**DEVELOPMENT MANAGEMENT COMMITTEE**  
**Thursday 15<sup>th</sup> June 2017 at 7.00 PM**

**ADDENDUM SHEET**

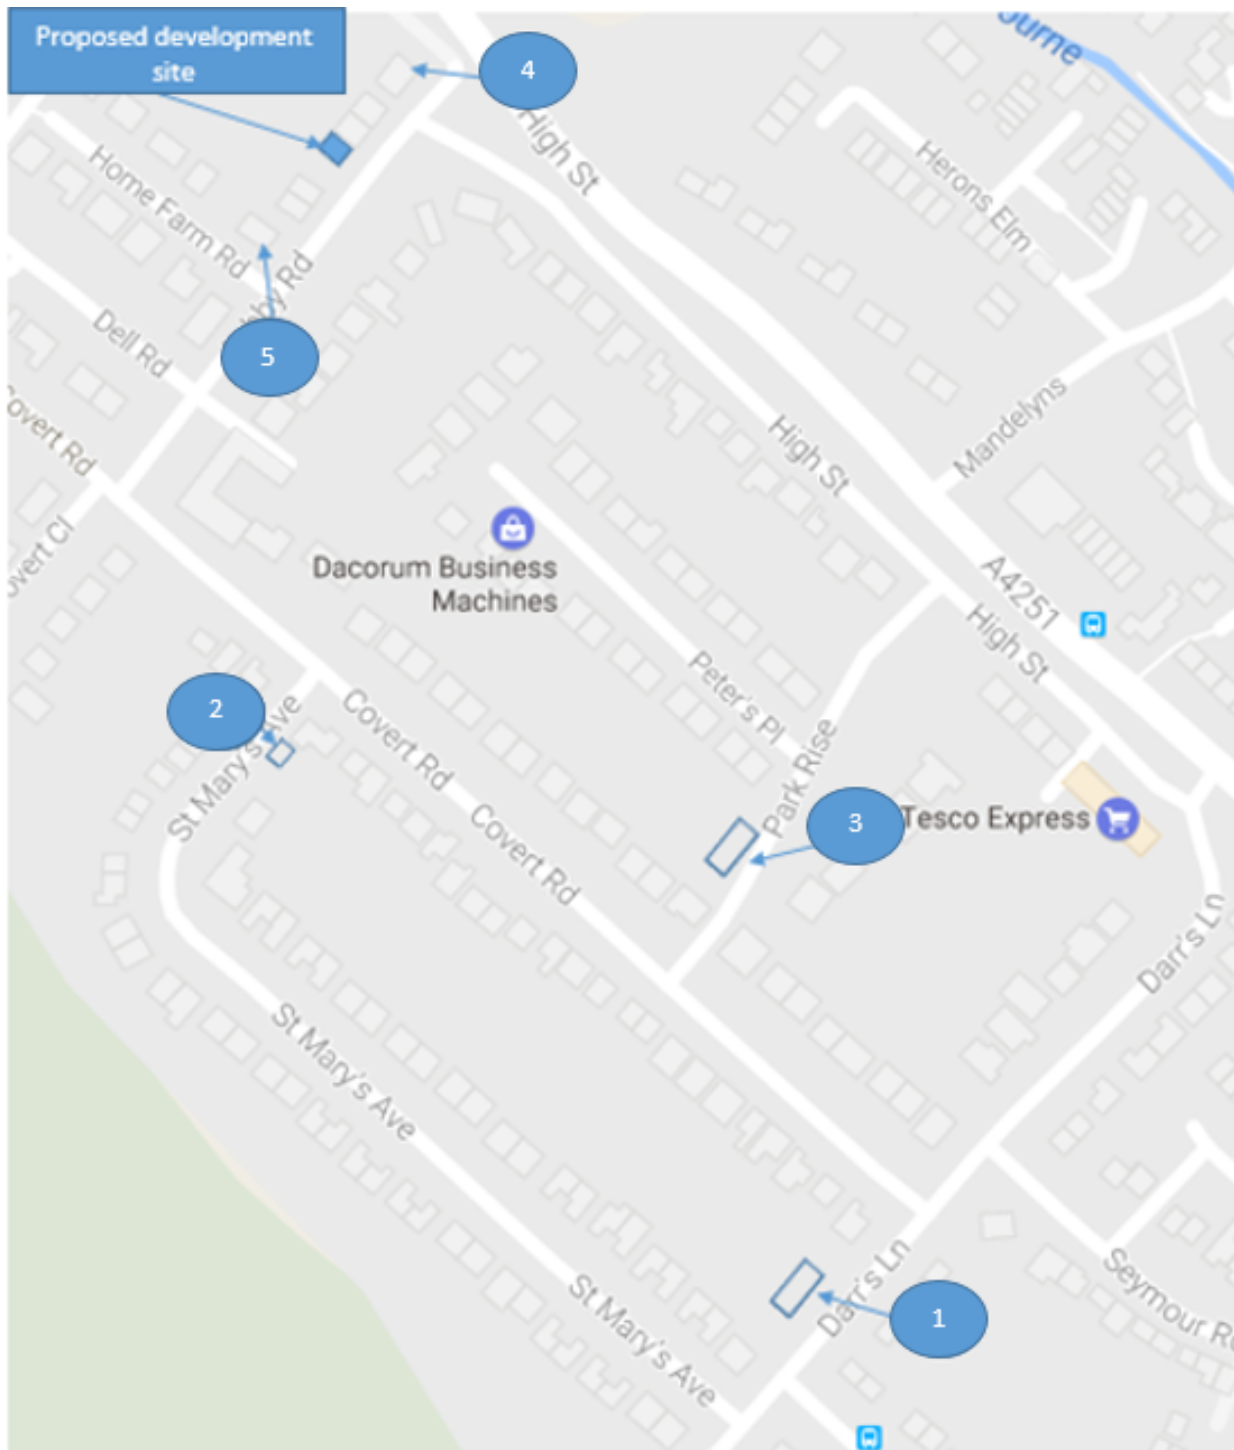
- Doesn't take into account the protected trees blocking light into the front window
- Doesn't note the downstairs bathroom
- Doesn't note the height difference of the window at the front , which is a lot smaller, compared with the side window

However I do appreciate that 4 Ashby Road does have dual aspect windows that mean that some light will be available but there are recent examples of good design that ensure light impact is kept minimal which should be pursued giving the house has had the right to light from the 2 side windows since the 1920's and as the report notes impacts this significantly/

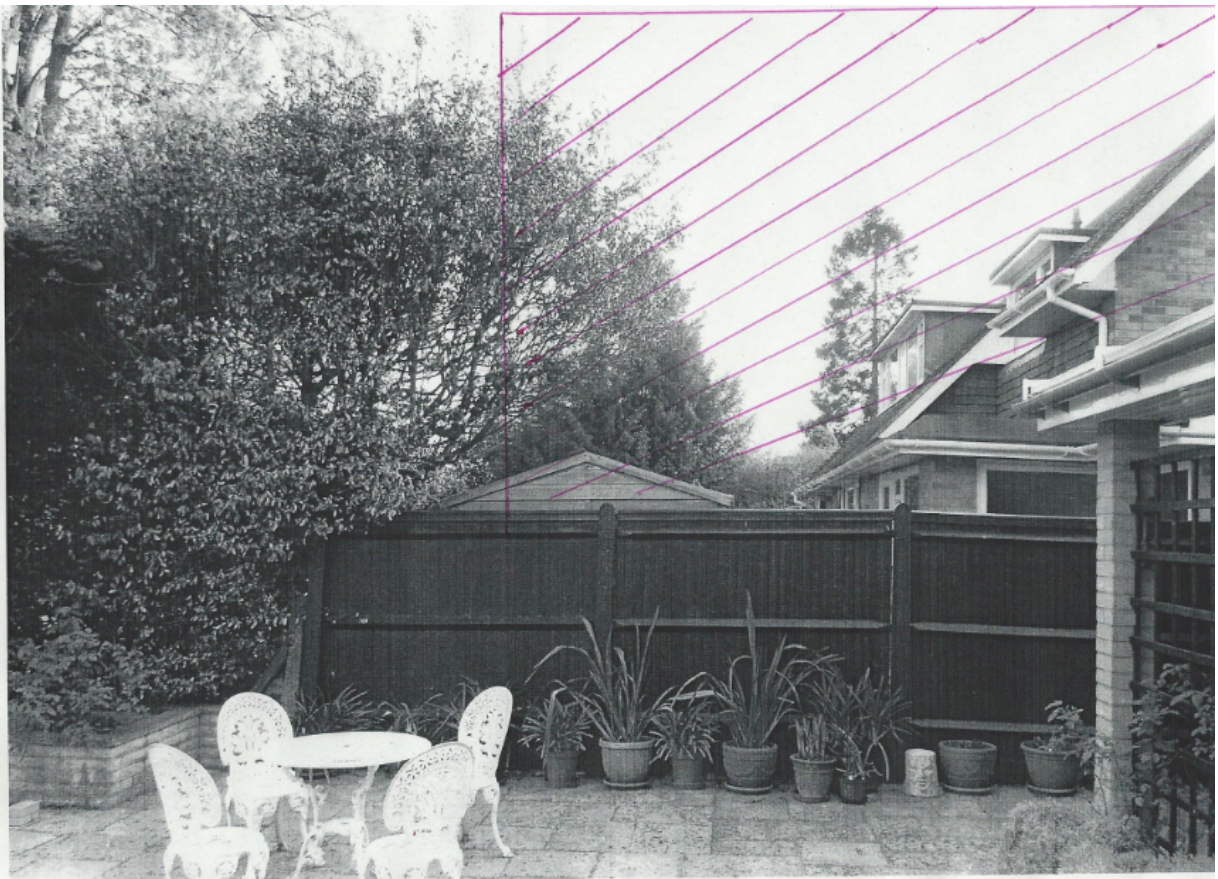
Now that clearer measurements have been provided, we note that the length of the 2-storey extension of plot 10a, adjacent to our boundary, is 3.4m at ground floor level.

However, we would stress that our primary concern is the height and mass of the 2-storey extension.

The existing property is, like 12 Wrensfield, being of the chalet style and the length of the new extension at first floor level will be approximately 5.4m. The ridge of the proposed extension will be approximately 8.4m. in length. The ridge heights of this row of houses (nos 6-16 Wrensfield inclusive) are high and the ridge of the 2-storey extension rises to the height of the ridge of the existing roof throughout its length.

As a consequence of the above and the close proximity of this new extension to our boundary and the rear of our house, we consider it to be overbearing. Furthermore, as the extension is located on the S-W boundary of our property, the degree of overshadowing, loss of natural light and diminution of amenity to our rear living rooms and patio are utterly unreasonable. To emphasise the above, we enclose an extract of one of the plans dated 30 May showing the N-E elevation of house 10a, together with a further copy of one the photographs of the rear of our house which were provided with our earlier letter and upon which we have drawn the extent of the 2-storey extension.
